3rd Street Improvements Jefferson Street to Blue Parkway
PROJECT NO. 575

ADDENDUM NO. 3

SHEET NO.	176	TOTAL SHEETS	204
DATE PREPARED	08/23/2024		
ROUTE	3RD ST	STATE	MO
COUNTY	JACKSON		
CITY	LEE'S SUMMIT		
PROJECT NO.	2020-575		
FEDERAL PROJECT NO.	TAP-3378(402)

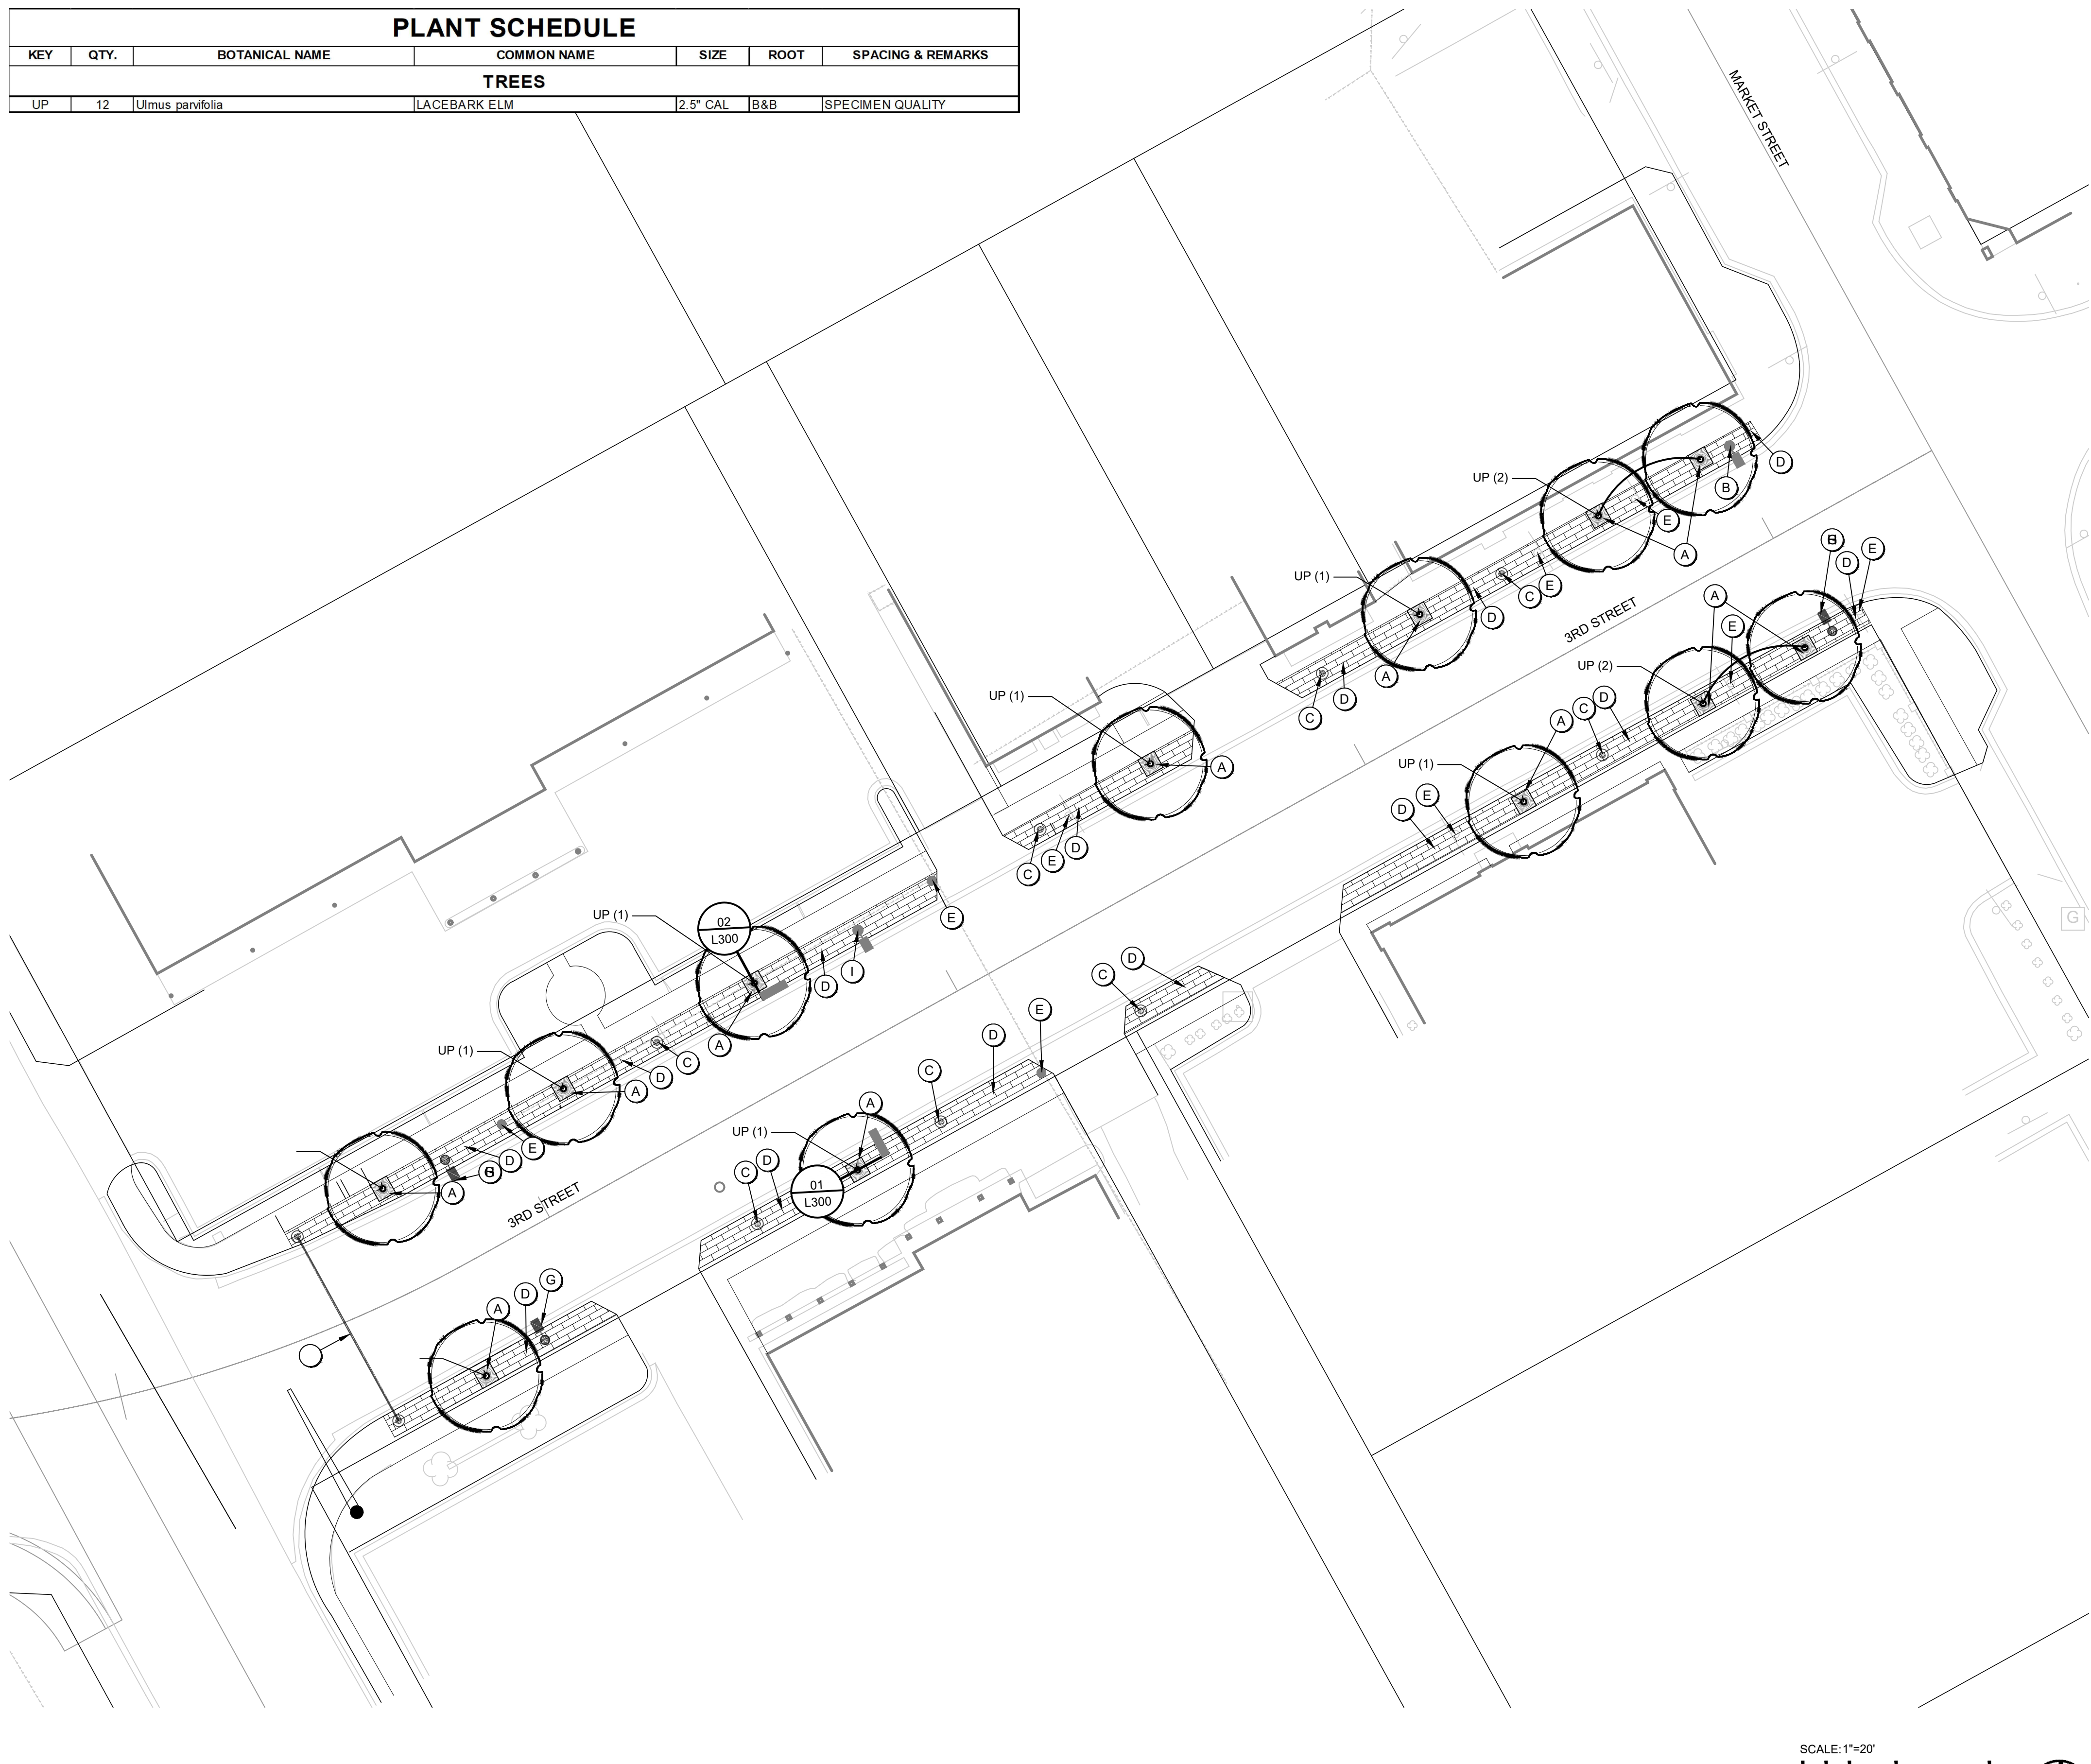
6. Sheet 175 & 176 – Item G in the legend was changed to “Future Shepard’s Hook (by Others)” and the changes on sheets 74 & 75 are reflected with changed callouts at those locations.
